Gouvernement du Québec

## **O.C. 437-2025, 19 March 2025**

### **Regulation to amend the Construction Code**

Figure A-3.8.4.3.-A

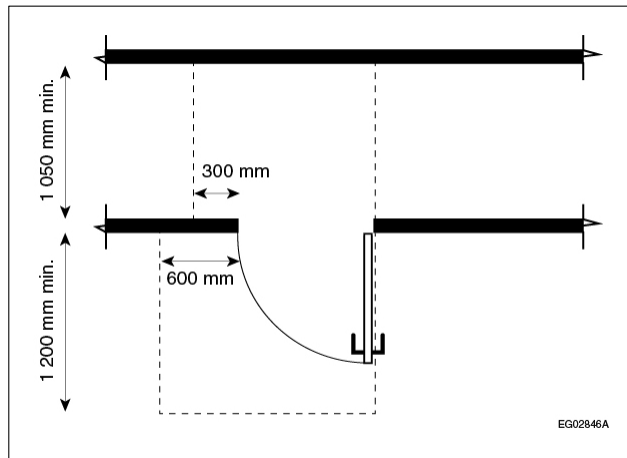
<p>Add the following Notes:</p> <p>“<b>A-3.8.4.2.(1)(a) Visitable Dwelling Unit.</b> In a visitable dwelling unit, if the washroom is inside another space (washroom inside a bedroom) and no other washroom is accessible in the dwelling unit, the barrier-free path of travel required must extend inside the bedroom or that other space to reach the washroom even if no accessibility requirement is applicable to that room.</p> <p><b>A-3.8.4.3. Doorways and Doors.</b> Clear floor spaces on each side of a door are necessary to allow persons in wheelchairs to approach the door on the latch side, open the door and enter the room while minimizing the number of manoeuvres. The width of the clear floor spaces on each side of the door is different depending on which side the door opens. Where the door swings toward the approach side, a dimension perpendicular to the closed door not less than 1 200 mm is required.</p> <p>The requirements in Article 3.8.3.6. apply to the door at the entrance to the dwelling unit, except that the requirements in Sentence 3.8.4.3.(2) do not apply.</p>

Figure A-3.8.4.5(4)

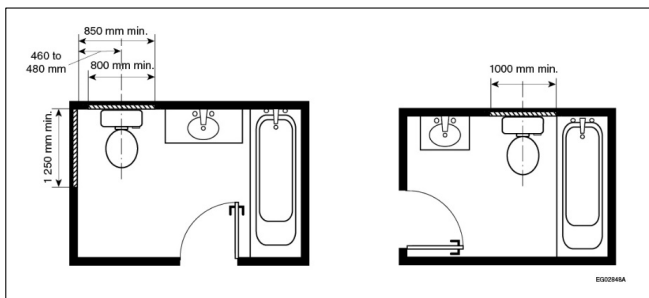
**A-3.8.4.5.(4) Reinforcement in a Washroom.** The installation of a reinforcement not less than 1 000 mm wide centred on the water closet is permitted where there is no wall adjacent to the water closet at a distance not more than 480 mm from the centre line of the fixture or the floor flange, allowing the installation of a lateral reinforcement over a length not less than 1 250 mm. A reinforcement not less than 1 000 mm wide allows the installation of fold-down grab bars on both sides of the water closet.

Figure A-3.8.5.5.(1)

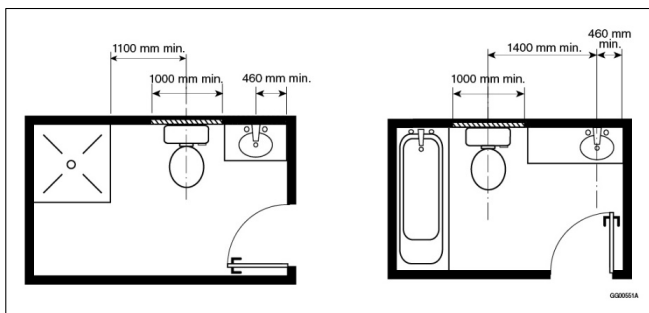
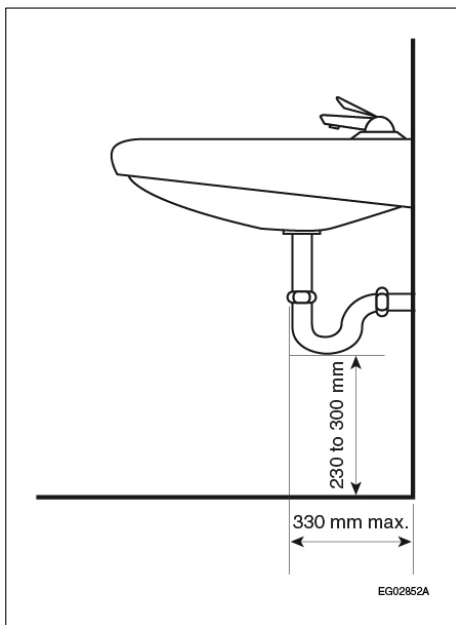
**A-3.8.5.5.(1) Lateral Transfer Adjacent to the Water Closet.** The lateral transfer of a person in a wheelchair to the seat of the water closet requires a clear width not less than 900 mm adjacent to the water closet and a length not less than 1 500 mm from the wall behind the water closet. The requirement related to that space for an adaptable bathroom allows the encroachment of a vanity or furniture for dismantling work, to meet the potential need of a person with physical disabilities occupying the dwelling unit. However, encroachment of that space by a fixture is not permitted.

**Figure A-3.8.5.5.(2)**

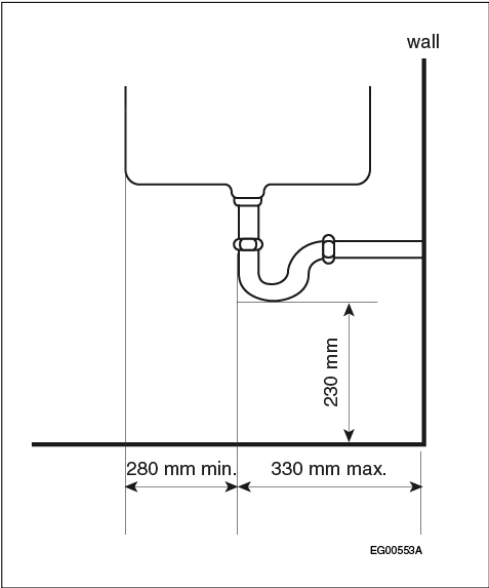
In an adaptable dwelling unit, the rim of the lavatory need not be at a height not more than 865 mm above the floor or to allow front access to the lavatory. However, an appropriate installation of the plumbing is required to allow future adaptation.

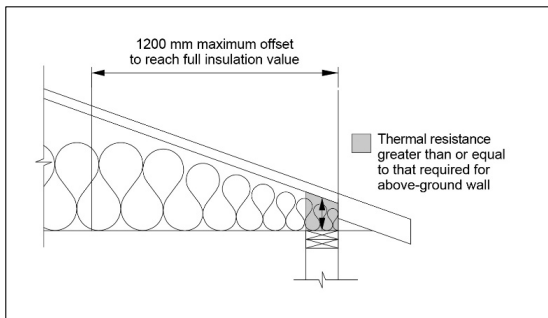
Provision	Amendments
A-9.36.2.5.(2)	<div>Replace Figure A-9.36.2.5.(2)-A by the following:</div> <div>“</div> <div>”</div> <div>Strike out the note in Figure A-9.36.2.5.(2)-A;</div>
